CITY OF FREDERICKSBURG

REGULAR PLANNING AND ZONING AGENDA WEDNESDAY, JULY 7, 2021 ~ 5:30 P.M. LAW ENFORCEMENT CENTER – 1601 E. MAIN STREET

Re: Site Plan Review Comments
SP-2106
619 W. Live Oak Street

619 WEST LIVE OAK
APARTMENTS
619 WEST LIVE OAK
FREDERICKSBURG, TEXAS 78624

SITE PLAN

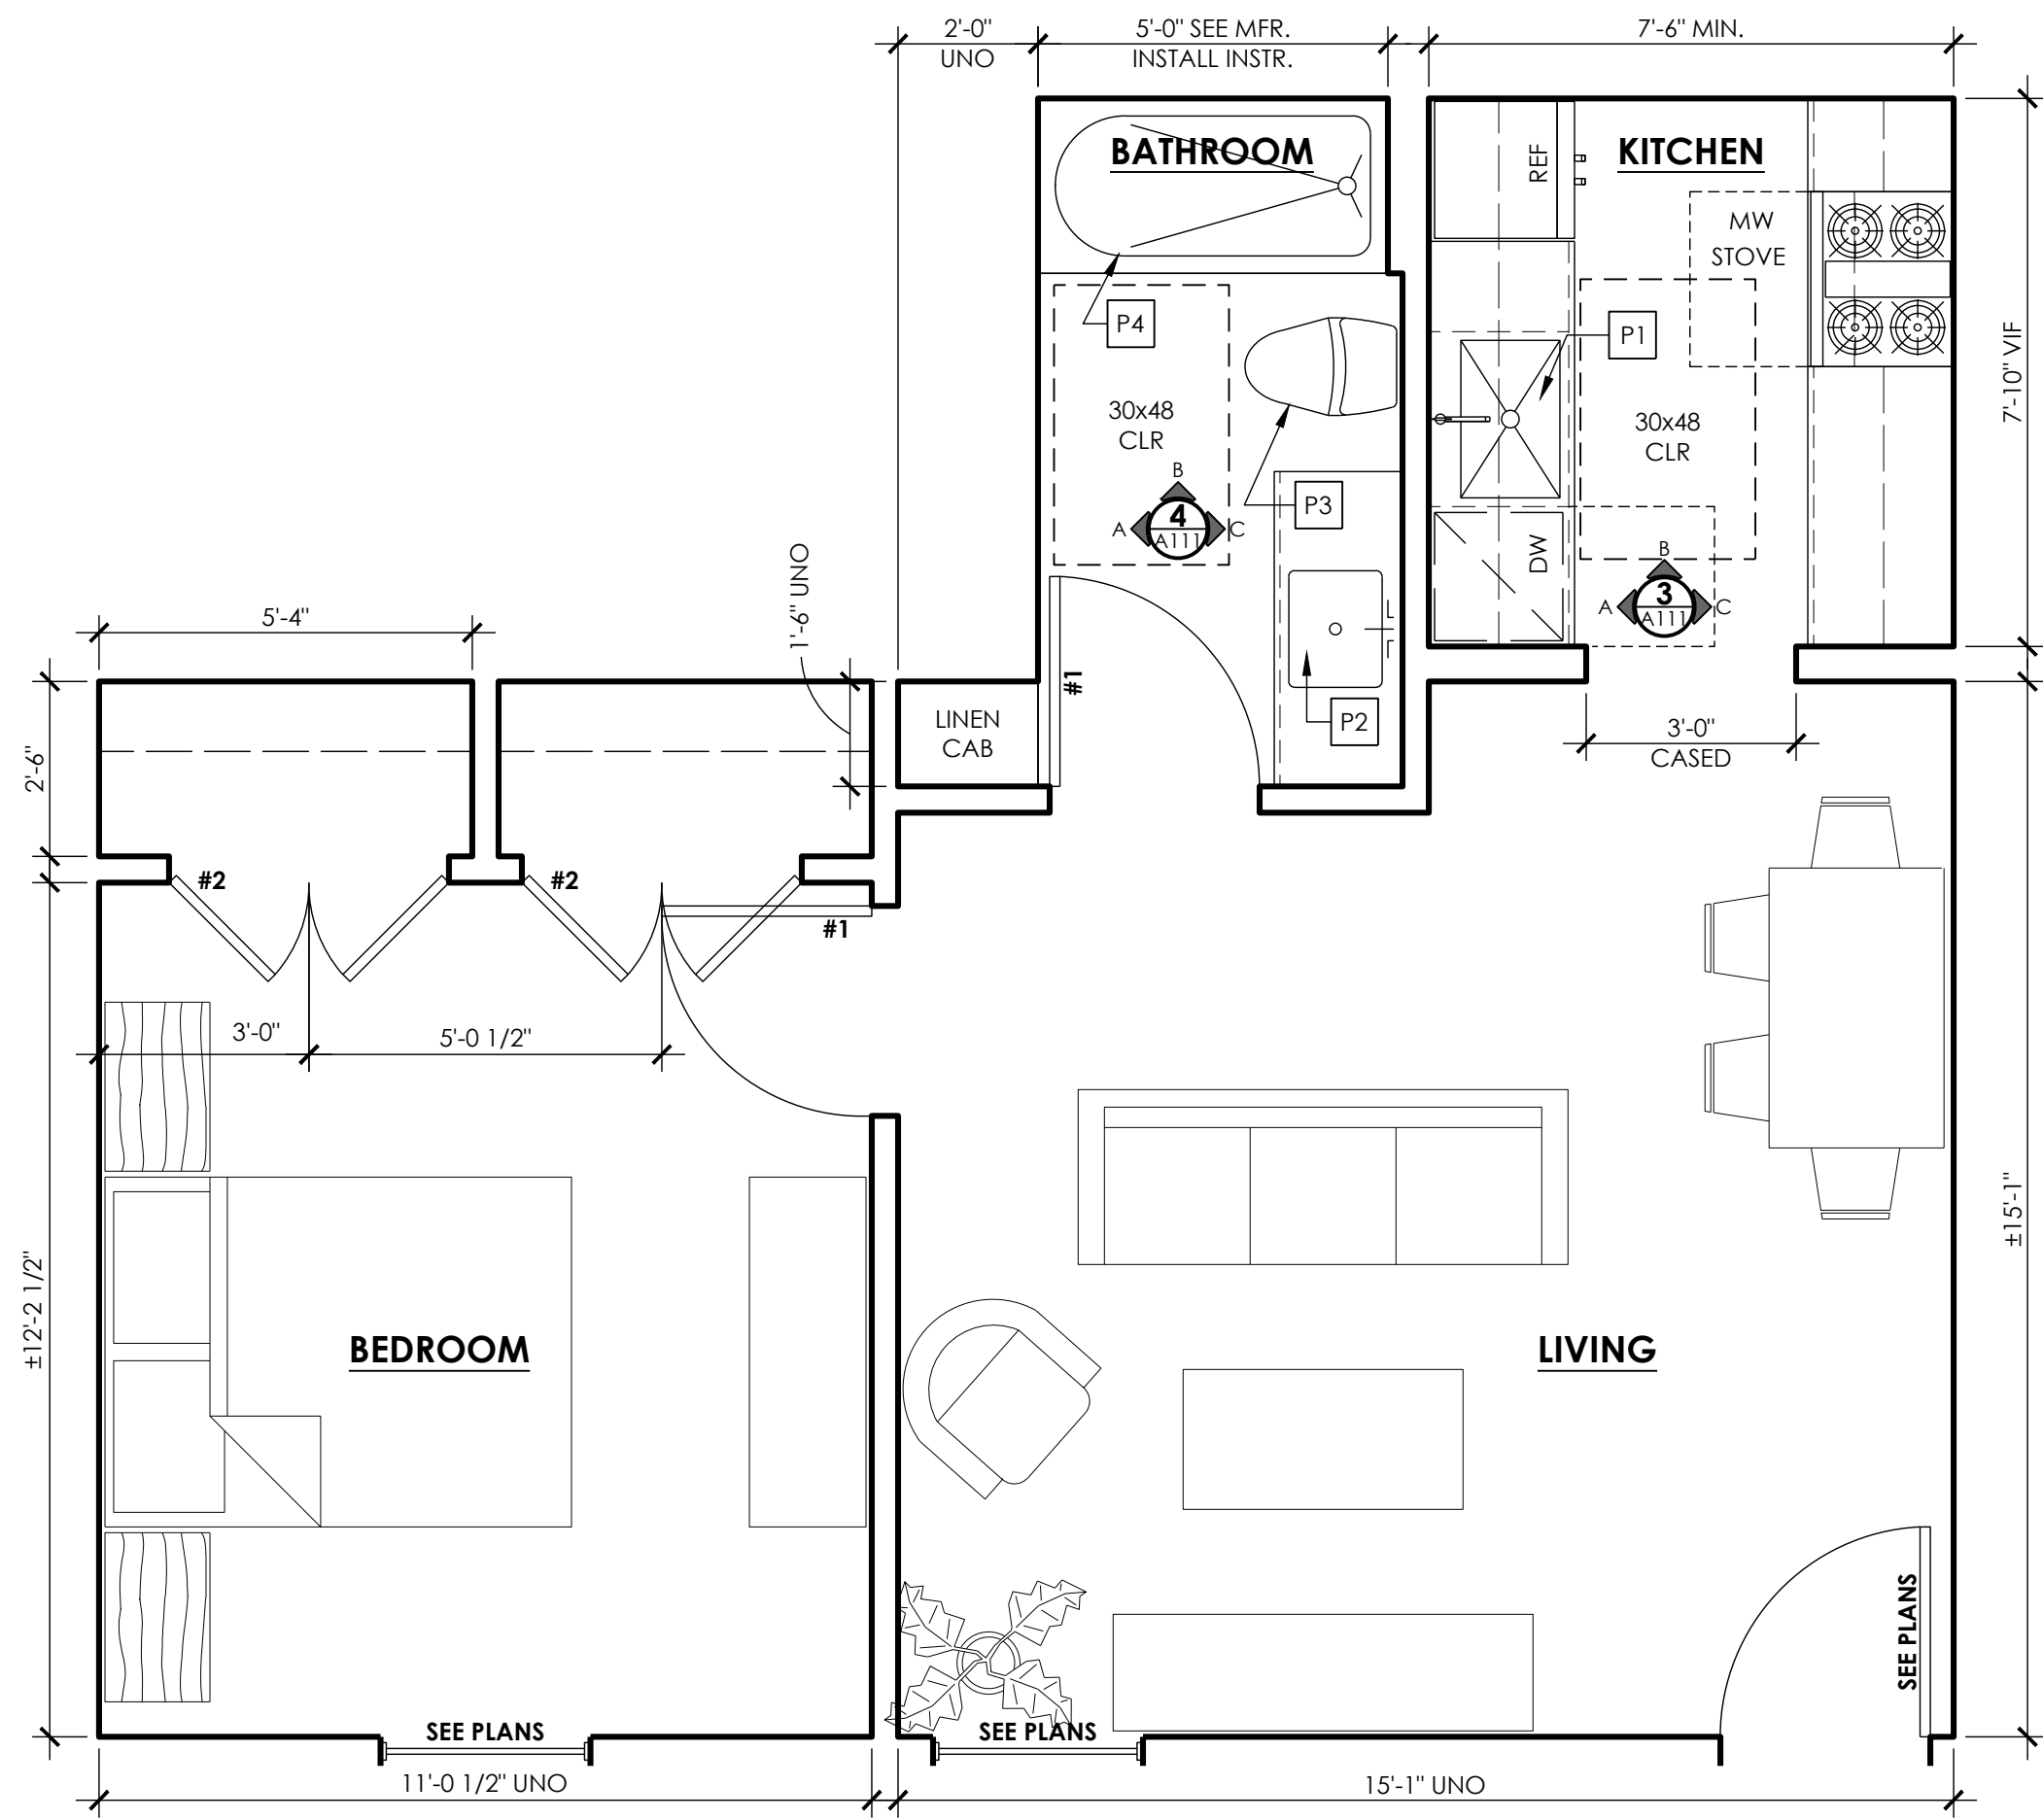
- a. Plat is required for the development of the property and must be approved prior to issuance of any building permits.

- a. Provide landscaping plan of the property in accordance with the above referenced section.
- b. Include interior/Parking landscaping requirements.

- a. Provide a unit breakdown of the types/numbers of bedroom units so staff may verify density calculations and parking requirements.

- a. Provide a table showing building footprints (sq. ft.) so staff may verify lot coverage & building coverage.

5. Relocate or reorient dumpster enclosure to prevent garbage collection trucks backing into W. Live Oak Street.

6. Please dimension the width of the proposed access drives. Dimension the distance from center to center of the proposed drives and the distance of the western drive from the west edge of the property. Note the spacing requirements of the drives should be consistent with the subdivision ordinance section 6.04 H. (table 7). W Live Oak Road is a collector according to the City' comprehensive plan.

7. This development is subject to the City's stormwater control ordinance. Please show flow arrows showing drainage patterns for the site and location of stormwater control infrastructure.

- a. Ok. There is a civil engineer and surveyor now on the project working towards getting the plat issued.

- a. The site plan has been revised to indicate conformance with the city ordinances(Ch. 5, Article 7, Section 5-423 & Appendix B: Zoning). The final landscape plan will be developed by a professional designer, which the owner is in the process of retaining.
- b. The notestrip on the site plan has been revised to include approximate calculations for interior landscaping based on parking requirements.

- a. Unit breakdown chart has been provided on revised site plan notestrip. Accompanying unit plans have been attached as supporting documentation.

- a. Site Coverage Calculations have been elaborated in the revised plan. The chart now includes building coverage tallys.

- a. The dumpster enclosure orientation has been revised to mitigate the concern of trucks backing onto W. Live Oak St.

- a. The revised site plan shows the dimensions of the accessways to prominent nearby locations; i.e. intersections and adjacent driveways.
- b. The site plan was also revised to comply with Ch. 38, Section 6.04, Design Standards.

- a. The flow arrows and drainage patterns are in process and pending the site's recent survey. The general flow, topographical decline, is to the northeast corner. As such we have located retention swells along the eastern abutment, these will be pending the design of the civil engineer.
8. This site will require review of civil construction plans by the City's engineering department prior to initiating construction.

- a. Ok. The civil engineer is in process, developing the necessary documentation.
